UWNR University of Wisconsin-Madison

Subject: Docket 50-156, License R-74
Response to Request for Additional Information
for License Renewal to Facility License No. R-74
University Of Wisconsin Nuclear Reactor
TAC No. ME1585 (Technical RAI)

Responses to License Renewal Request for Additional Information

Figure 1, Historical Pool Water Makeup Trend

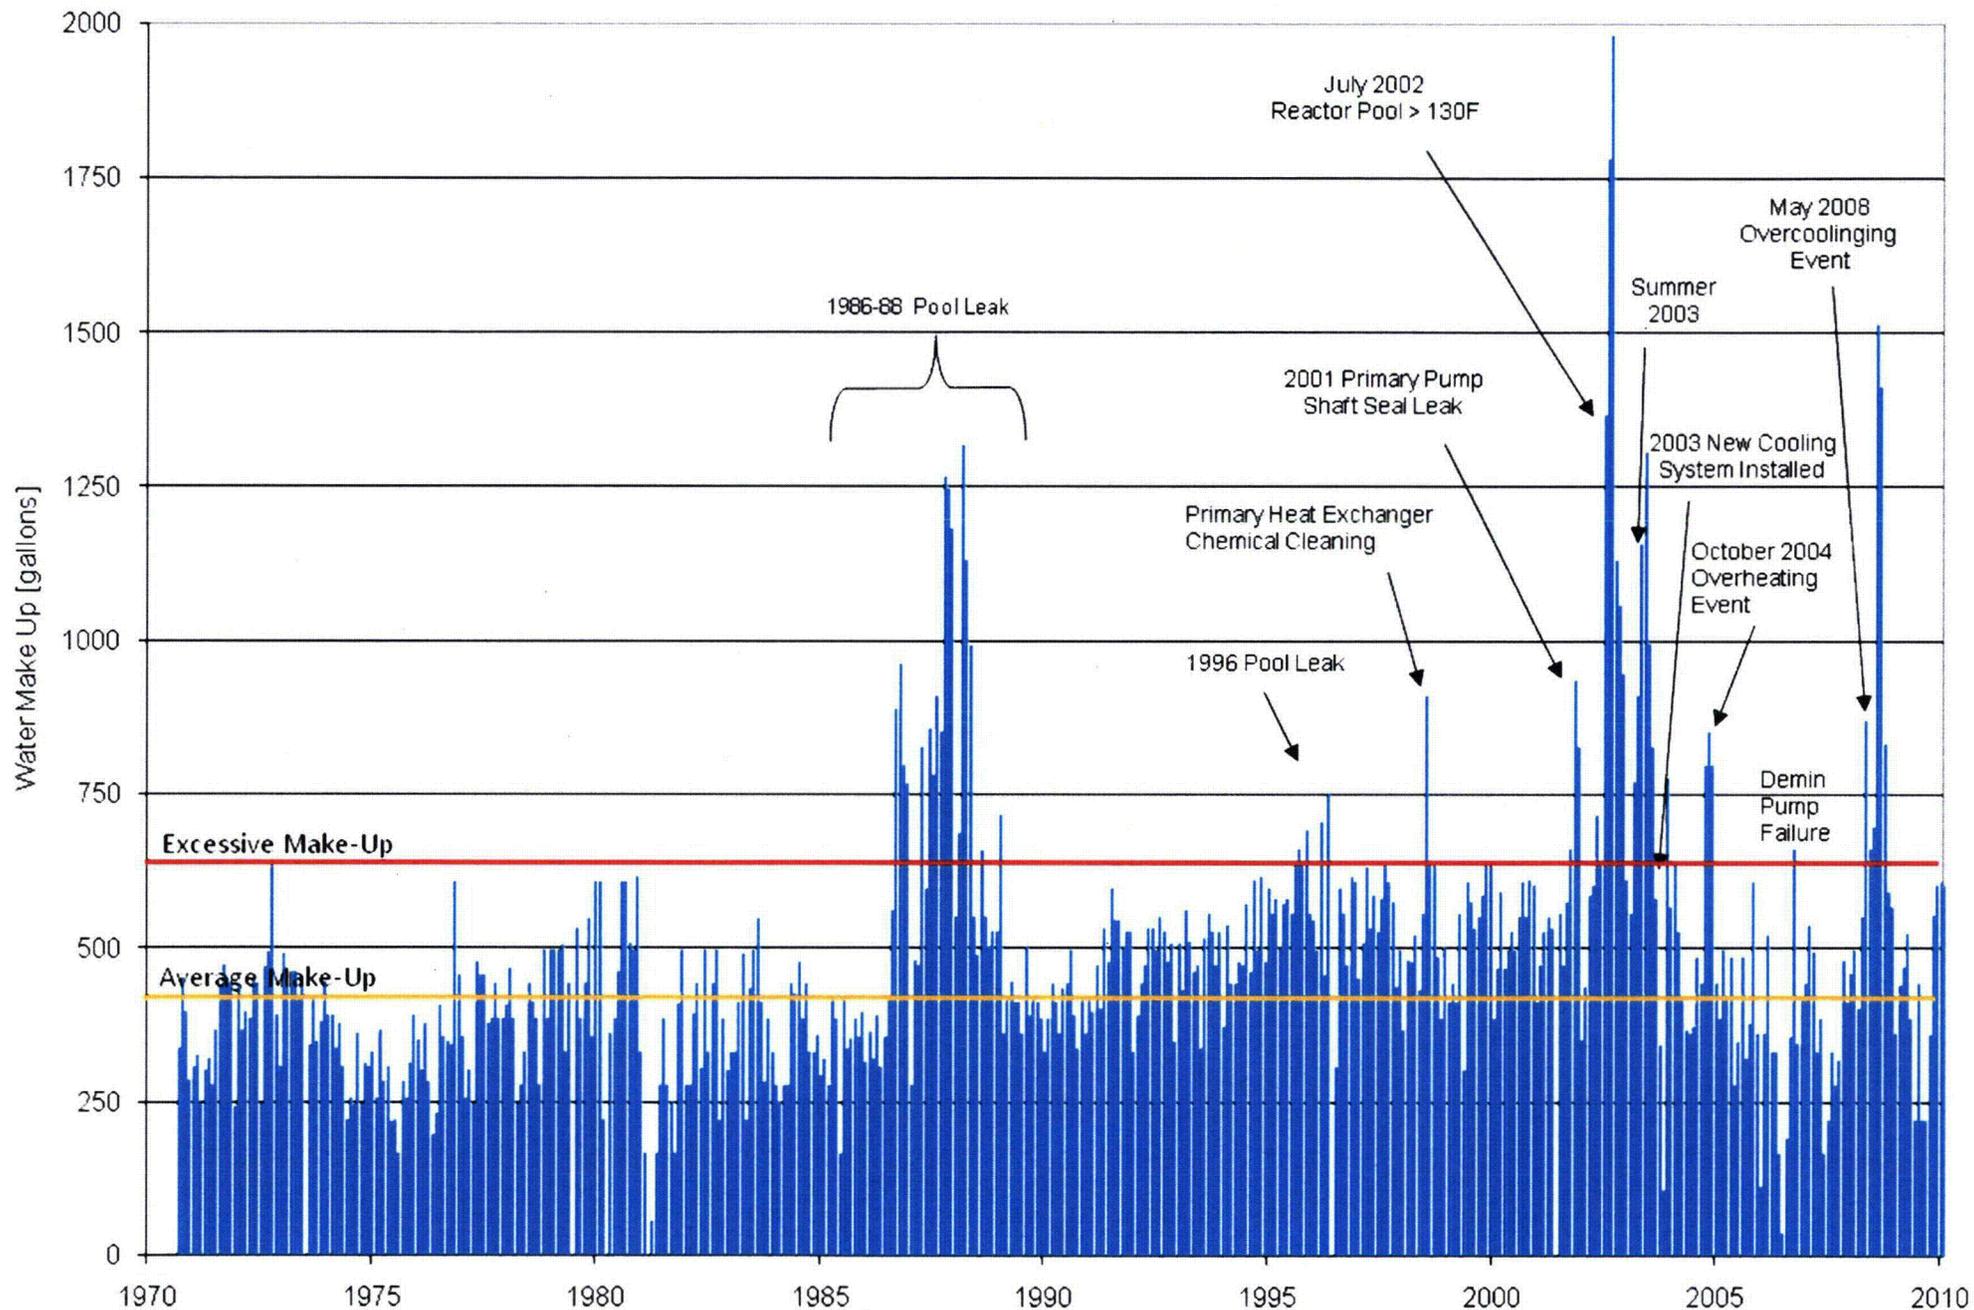
a. Please include in the discussion a description of the typical radioactivity content of the pool, the frequency with which the pool water is analyzed for radioactivity, the pathways known or expected to be contributing to the leakage, any trends associated with the leakage, and the physical means with which UWNR can detect small releases from the pool directly to the environment.

A 40 year history of monthly pool water make up is depicted in figure 1 below. Water is routinely added to the pool to make up for losses due to evaporation, sampling, and even thermal contraction of the water. The average make-up volume, excluding those periods of time of known leakage, is approximately 450 gallons per month. The standard deviation in the make-up rate is 150 gallons and is due to variations in seasonal temperatures, humidity, the number of full power operations in a month and even the number of days in the month. Because the original cooling system utilized a cooling tower as the ultimate heat sink, the cyclic trend of summer temperatures can be seen to increase the pool make-up due to increased evaporation as a result of increased pool water temperatures.

During previous pool leaks it has been shown that the cyclic change in pool water temperature during full power runs led to excessive flexing of the aluminum pool liner given the large coefficient of thermal expansion for aluminum. As the aluminum liner stretched and contracted, minor cracks in the pool liner welds were formed, and then re-sealed as the temperature stabilized. Historically the only known leak path has been through cracks in the corner welds around the thermal column, through the pool concrete and into the compacted fill below.

Following the development of the 2002 leak, the cyclic nature of the increased leakage as a function of increased pool water temperature is obvious by observing the cessation of the leak in December 2002 and the reoccurrence in the summer of 2003. This trend of thermal cycling the aluminum liner and increased leakage is also demonstrated by an over-heating event in 2004 and an over-cooling event in 2008 that occurred at the facility following installation of the new cooling system.

Minor leaks are most easily detected by observing the monthly volume of make-up water added to the pool. Make-up volumes that exceed 600 gallons a month are excessive. This is evident in figure 1, where every leakage event correlates with make-up water volumes in excess of 600 gallons. Evaporation rates at the pool surface are also measured over a 24 hour period and can be correlated with the volume of monthly make-up water; however, these 24 hour evaporative rates have an uncertainty of +/- 5 gallons per day. Any volume of water exceeding normal losses is assumed to be lost to the environment and is reported as a direct environmental release.

Figure 14-1, Organization Chart

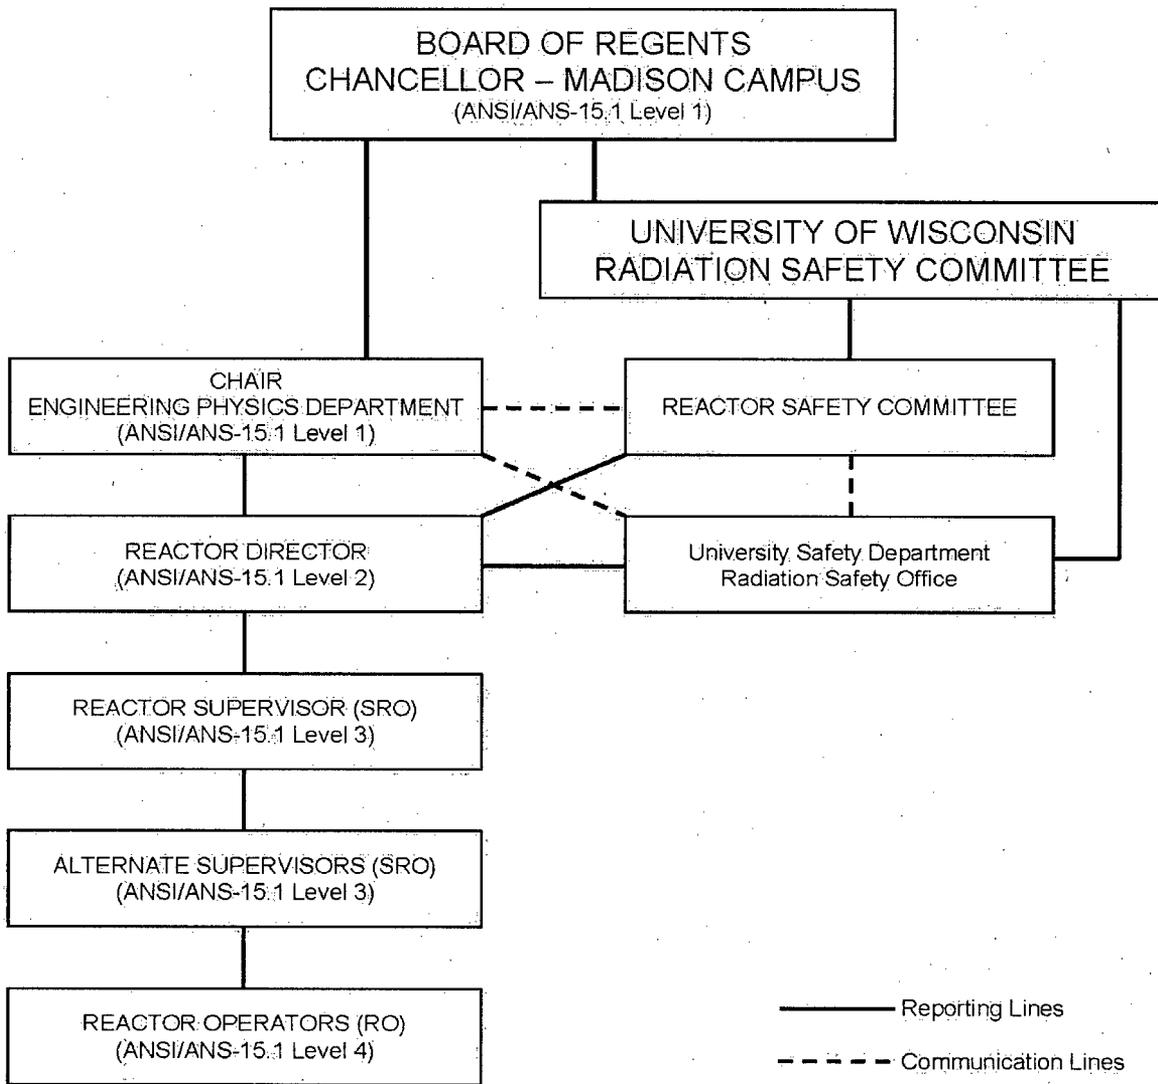
26. NUREG-1537 states that the format and content of the TS follow that of ANSI/ANS-15.1. ANSI/ANS-15.1-2007 Section 6.1.1 provides guidance related to organizational structure. UWNR TS 6.1.1 states that the Radiation Safety Office reports to "both committees as well as to the Reactor Director." However, the organizational chart has the Radiation Safety Office reporting to a level above the ANSI/ANS-15.4 Level 1 position. Please clarify the reporting structure for the Radiation Safety Office at UWNR.

Certain level 1 responsibilities of the Board of Regents of the University of Wisconsin, the holder of the reactor license, are delegated to the Engineering Physics Department chair. The organizational chart is revised for clarification below. See also Attachment 1.
